ALERT SERVICE BULLETIN
Bell Helicopter **TEXTRON**

NO. 206L-06-140

MODEL AFFECTED: 206L, L-1, L-3 and L-4

SUBJECT: UPPER LEFT HAND TAILBOOM ATTACHMENT
HARDWARE, INSPECTION OF

Figure 1: Tailboom Attachment

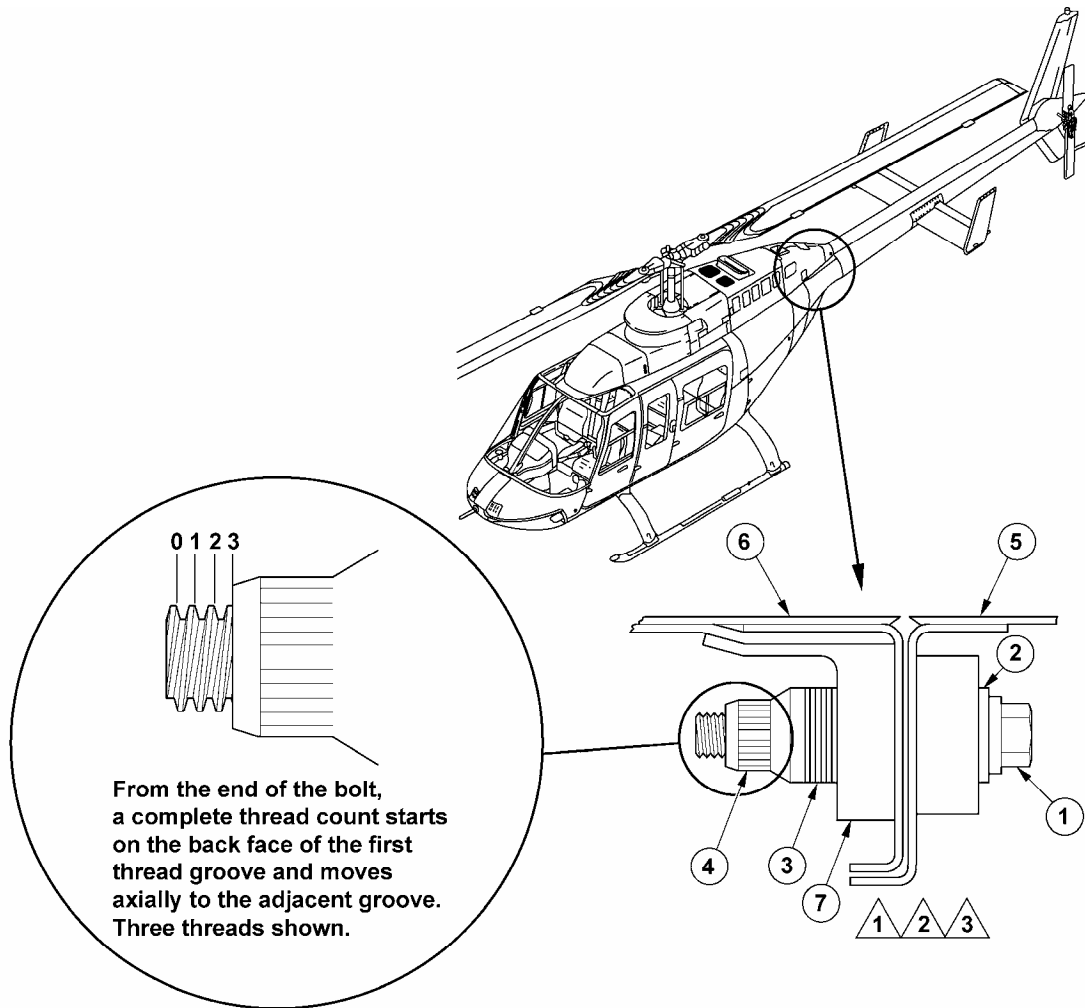
5. For helicopters affected by this bulletin that have a CRES fitting installed, perform thread count on the upper left hand attachment bolt (1) as per Figure 1.

7. If less than 1 thread is exposed, adjust the washer (3) quantity as required per Figure 1. Refer to the Maintenance Manual and torque as required. Make an entry in the helicopter records to indicate that this bulletin has been accomplished.

8. If more than 3 threads are exposed and a replacement bolt (1) is not available at this time, adjust the washer (3) quantity as required per Figure 1. Refer to the Maintenance Manual and torque as required. Make an entry in the helicopter records to indicate that the PART I of this bulletin have been accomplished and that the PART II of this bulletin will require accomplishment.

9. If more than 3 threads are exposed and a replacement bolt (1) is available, accomplish Part II of this bulletin.

1. Remove and discard the upper left hand tailboom attachment bolt (1, Figure 1). Install new bolt (1) and adjust the quantity of washer (3) as required to ensure correct installation as shown on Figure 1. If serviceable, the nut (4) does not require replacement. Refer to Maintenance Manual.
2. 100 hours after installation, do a torque check of the upper left hand tailboom attaching hardware. Refer to the applicable Maintenance Manual.
3. Make an entry in the helicopter records to indicate that this bulletin has been accomplished.

- 1 Bolt (1) and chamfered washer (2) are to be installed through tailboom (5) and Aft fuselage (6). Bolthead and chamfered washer are to be installed on the tailboom side. Steel washers (3) are to be installed next to fitting (7) to provide not less than one thread and not more than three threads exposed on threaded end of bolt (1).
- 2 If thread count is less than one, remove washers as required.
- 3 If thread count is more than three, remove and replace bolt, then readjust number of washers to meet requirement of note 1.
